ADDENDUM No. 3 TO PROCUREMENT CONTRACT DOCUMENTS
BRIDGEPORT PUBLIC UTILITY DISTRICT (BPUD)

Arsenic Removal Project – Arsenic Removal System Procurement Contract

May 17, 2017

Bridgeport Public Utility District – Arsenic Removal Project

TWIN LAKES ROAD
 PLAN & PROFILE

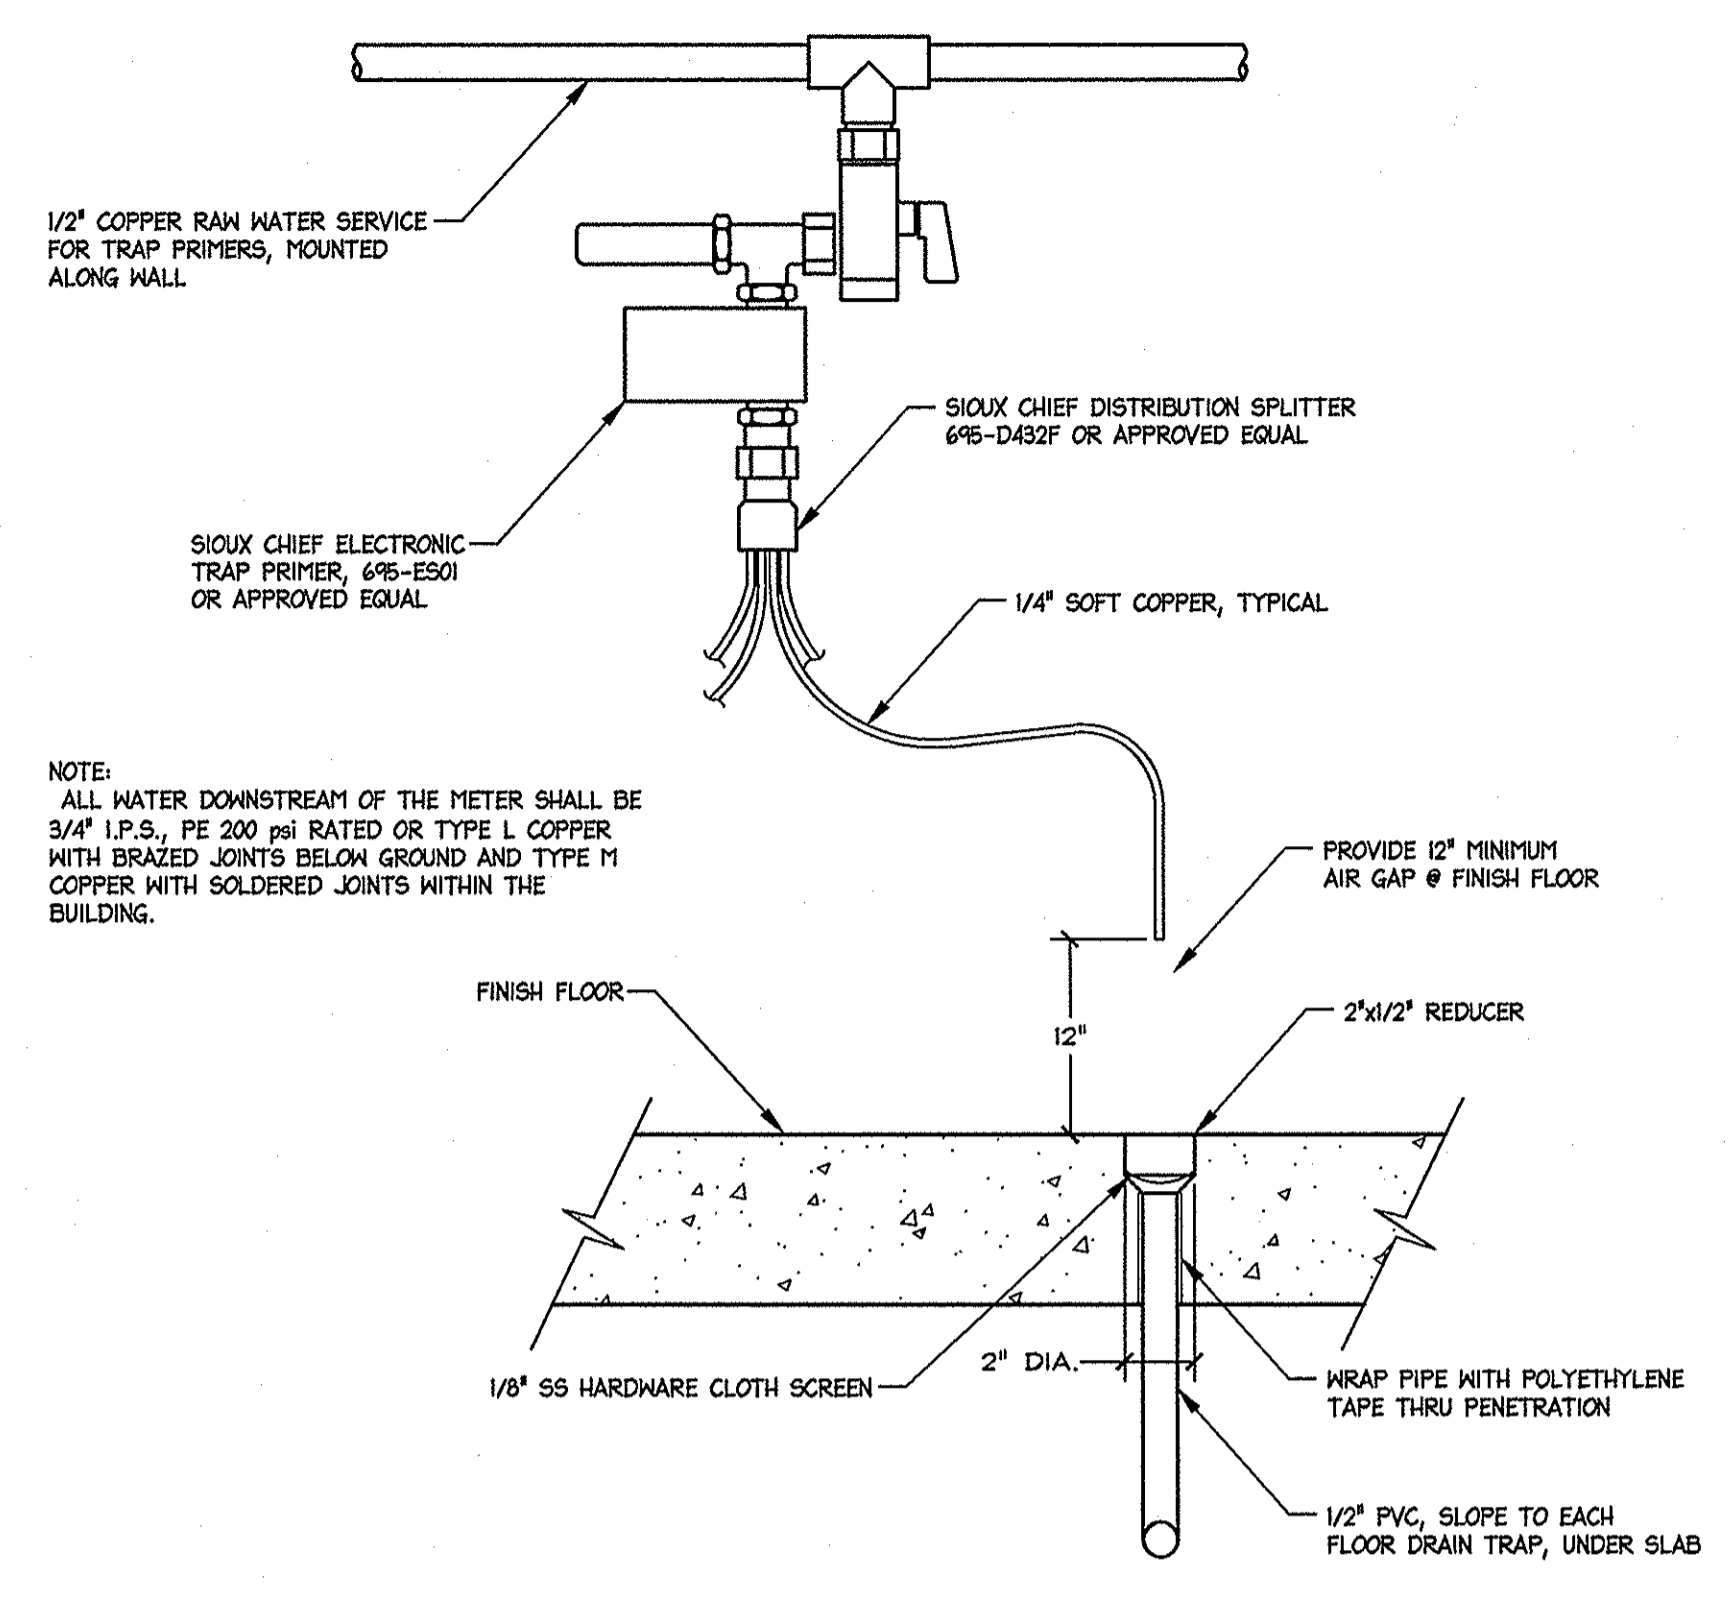
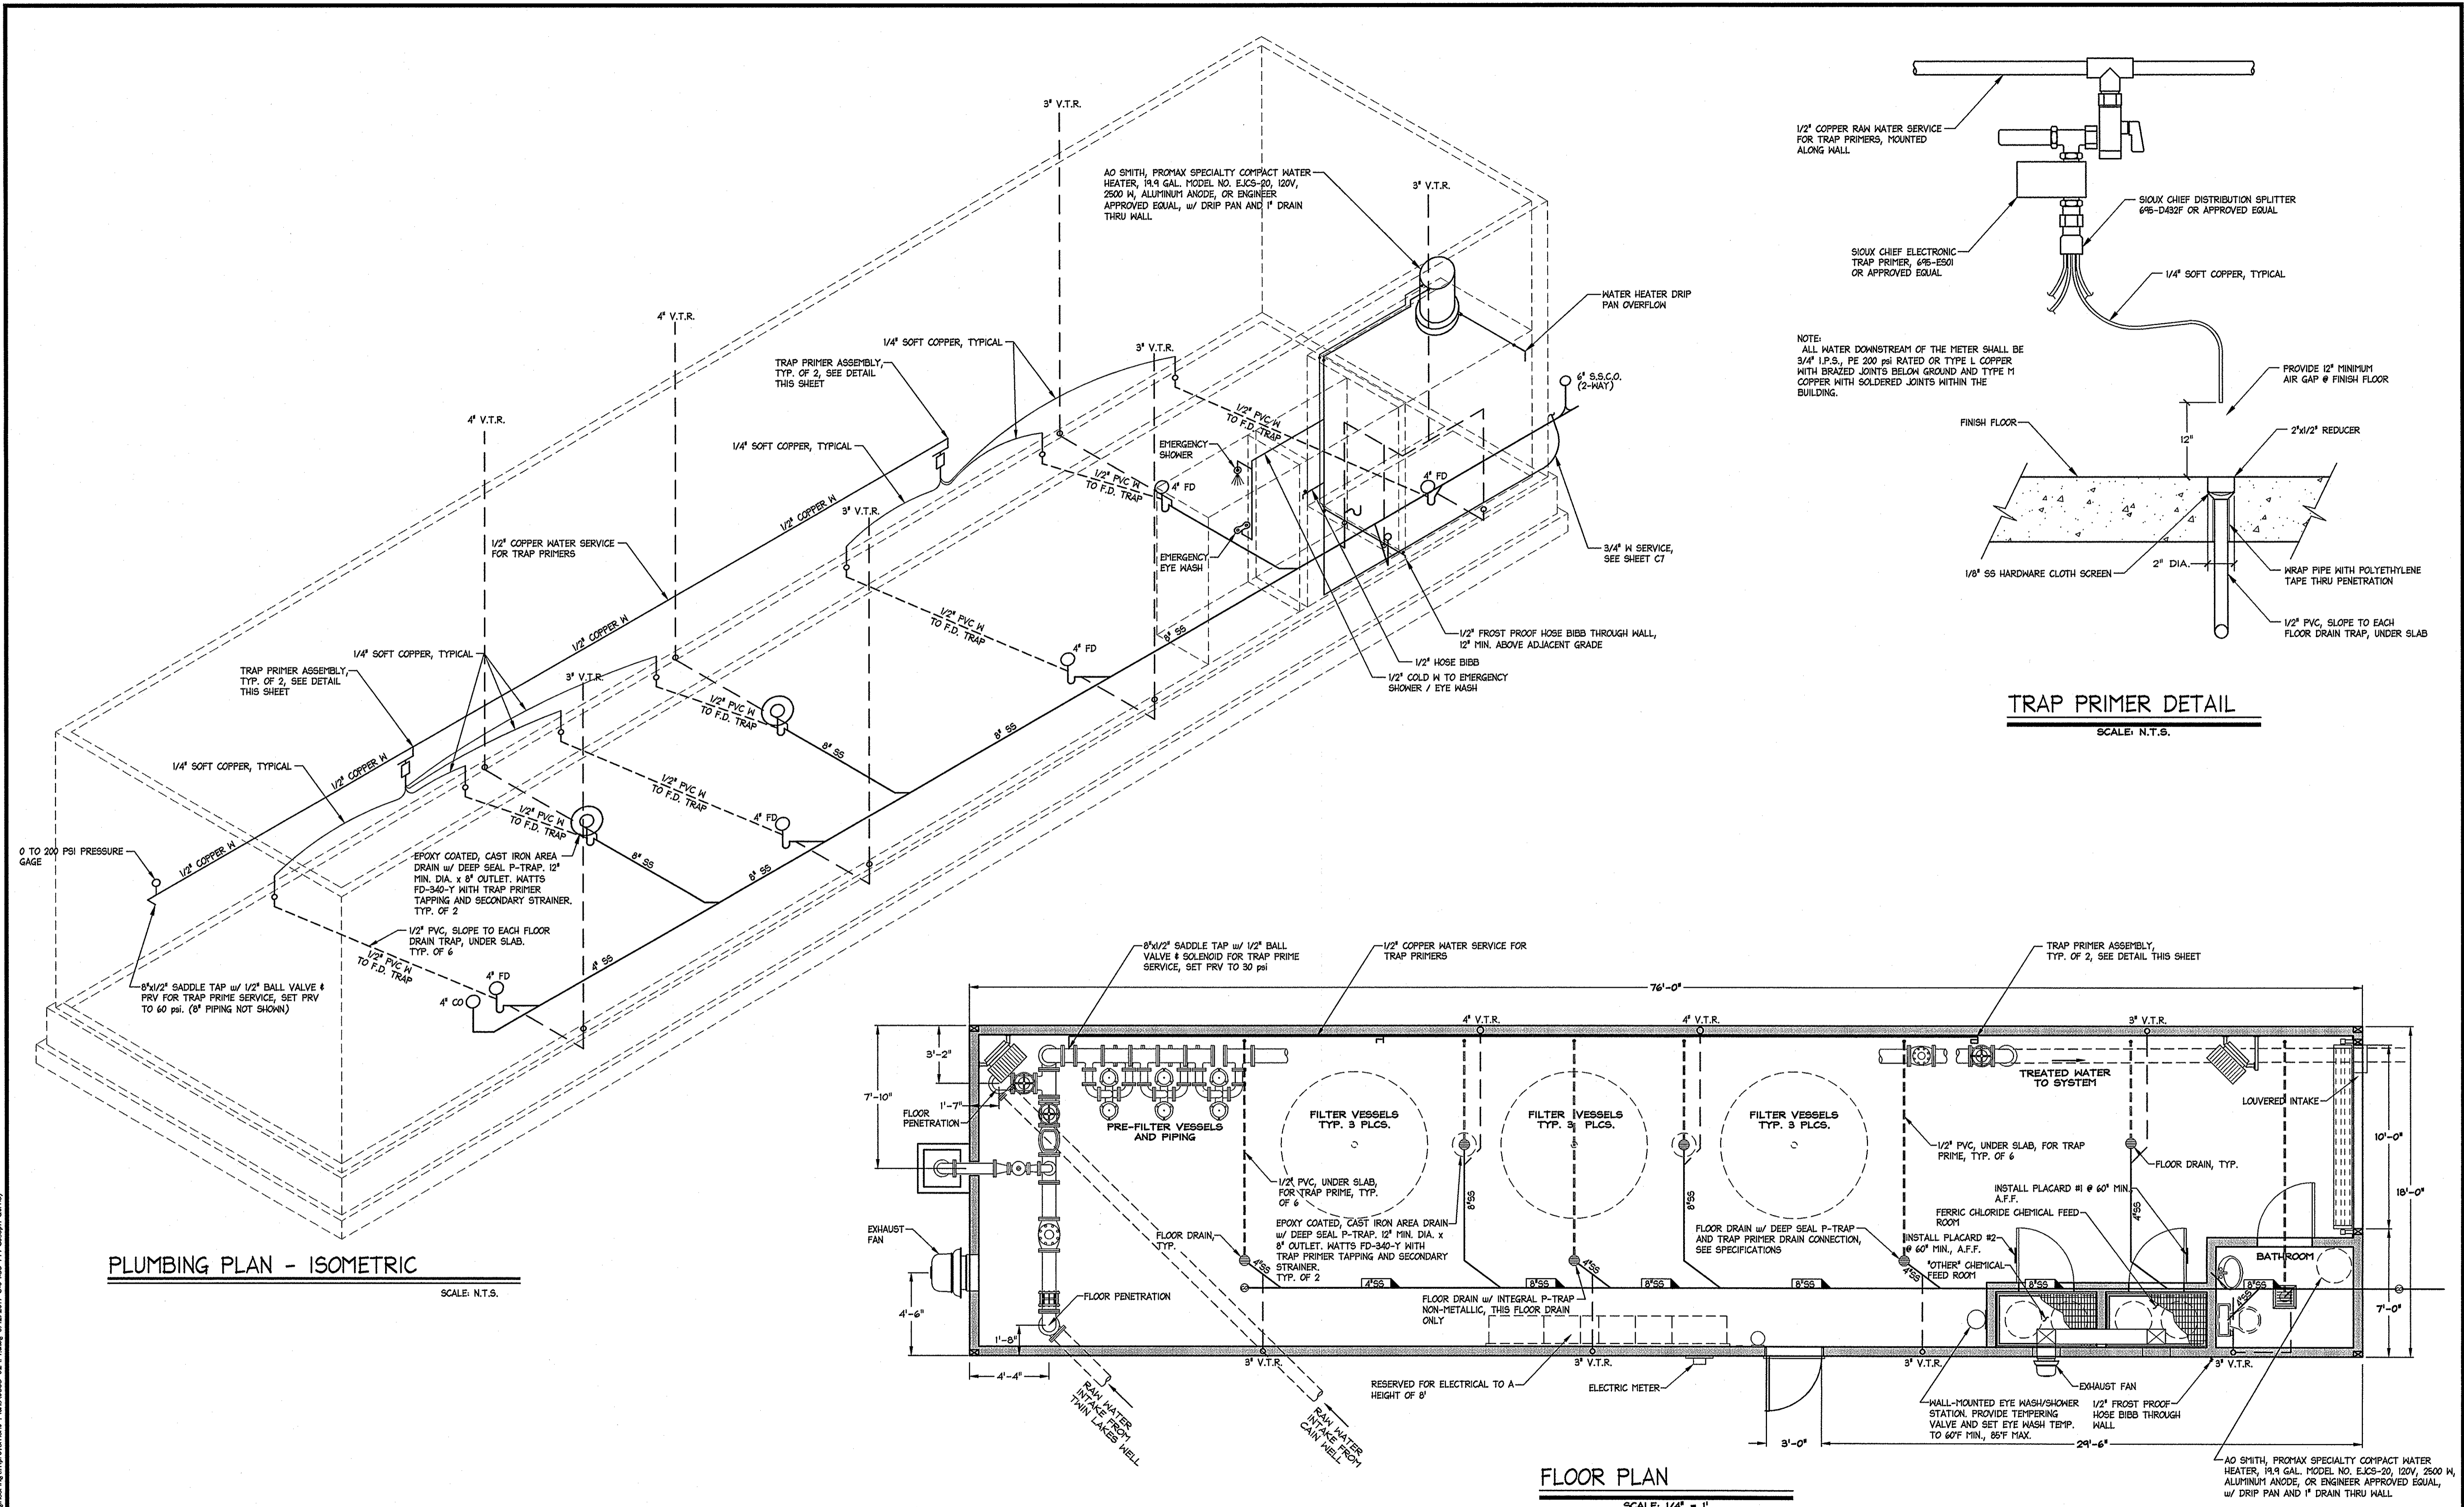
1. Extend AC Pavement Patch areas to large square at Kingsley Street and full width of Twin Lakes Road in front of site.

FLOOR PLAN

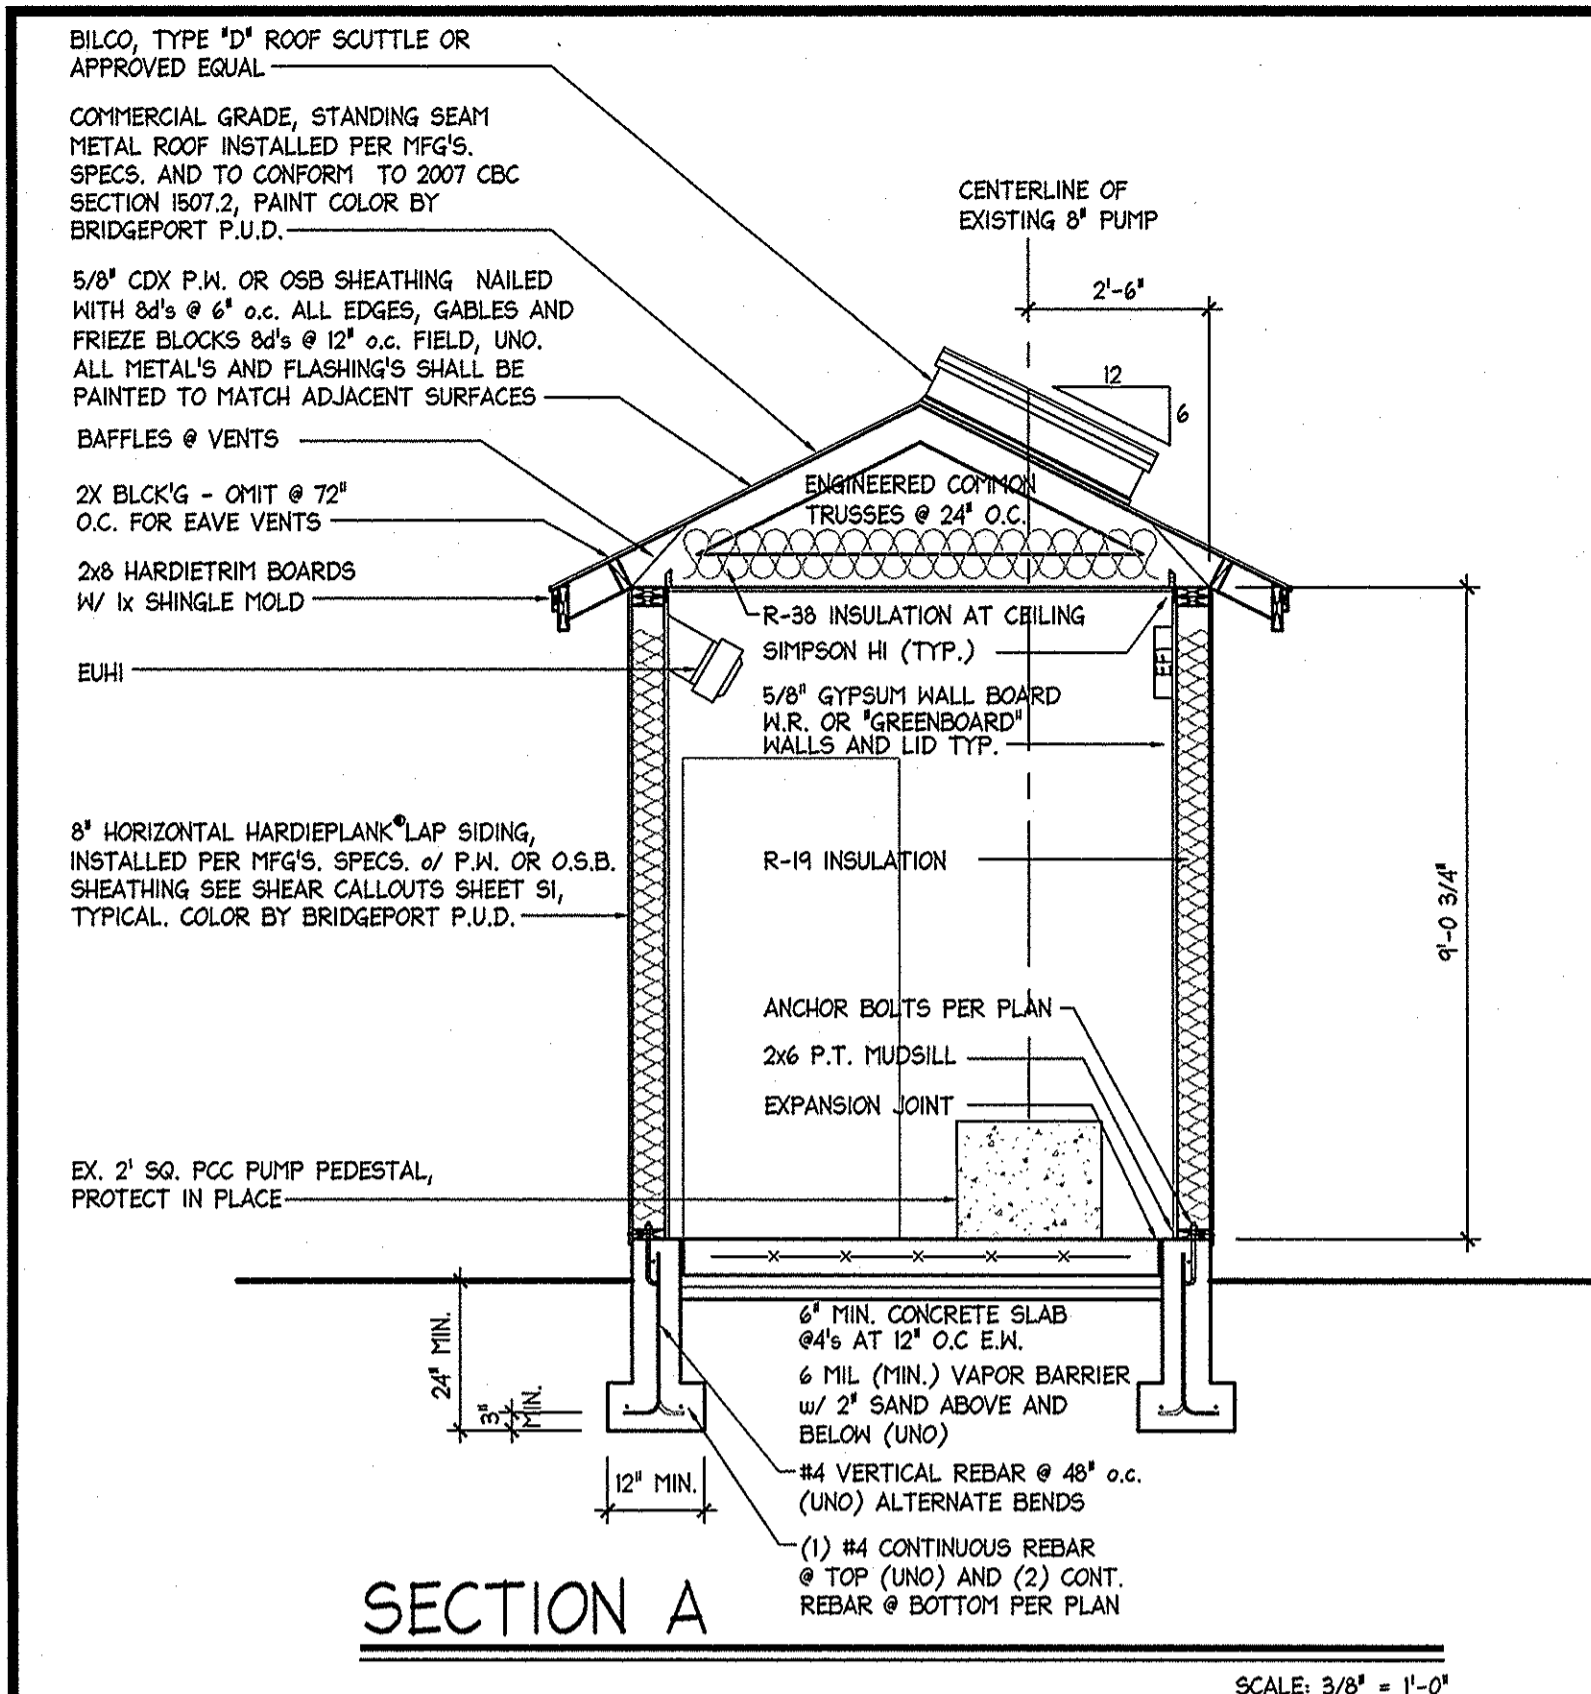
1. Addition of leader/text in front of electrical panel that reads “30” Minimum Clear Space is Required in Front of Electrical Panels.”
